#### Mack Trucks, Inc. Greensboro, NC USA

> PI0815, Rear Suspension Hardware Torque CHU, CXU, GU, TD

(February 2013)

W6078959

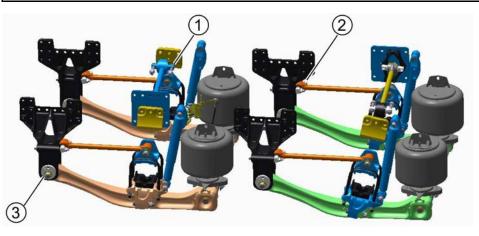
It has been discovered on certain Mack trucks that bolts are loose or incorrectly torqued on the Primaax suspension. The solution is to apply the correct torque from beam to hanger bolts, torque rod bolts - lateral and fore and aft.

Note: Verify that rear suspension is at proper ride height before torquing any joints.

1 Transverse TR:  $275 \pm 25$  Nm ( $203 \pm 18$  ft-lb) Both ends of torque rod. Torque front and rear bolts.

2 Fore-aft TR:  $320 \pm 50$  Nm ( $236 \pm 37$  ft-lb) Torque all four locations (8 bolts).

3 Pivot Bolt:  $745 \pm 35$  Nm ( $550 \pm 26$  ft-lb) Torque all four locations (4 bolts).
